Number: 78-2

OFFICIAL NOTIFICATION Under the U.S. Federal Boat Safety Act

WIRING HARNESS CHAFING

Figure 1. Installation of Insulating Conduit

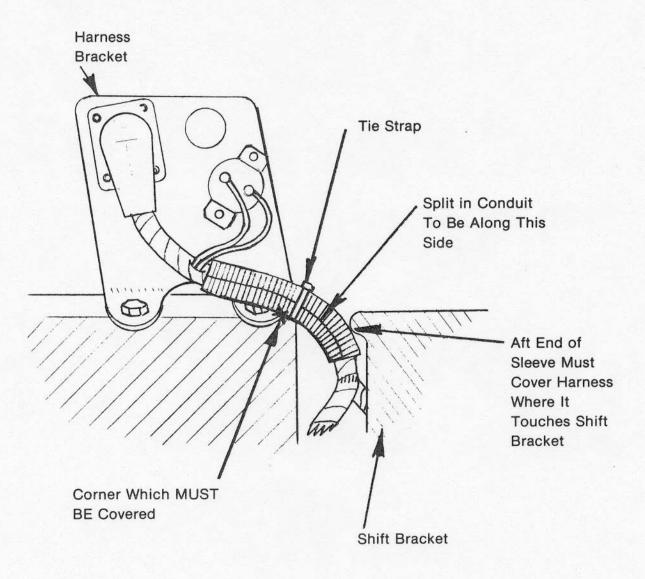
Mercury Marine has determined that the engine wiring harness on MerCruiser Models 898, 228, 250 and 260 can chafe against the harness connector mounting bracket. If this occurs, the insulation may be worn off the harness and allow a wire to contact the bracket. This can result in a short with damage to the electrical system and cause a potential fire hazard.

To prevent this situation from occurring, the installation of an insulator protector sleeve and tie-strap is necessary. Immediately, contact each customer--with boats equipped with MerCruiser models within the specified engine serial group, below-and have them arrange to check the harness and install an insulator protector sleeve, as illustrated in Figure 1 (over).

Also rework all engines in boats in your inventory. Order one Insulator Protector Sleeve (Part No. B-85-79844-1) and Tie-Strap (Part No. C-61990) each per engine. This is required under the Federal Boat Safety Act.

NOTE: If Harness Is Tied to Leg of Harness Bracket, Remove That Tie.
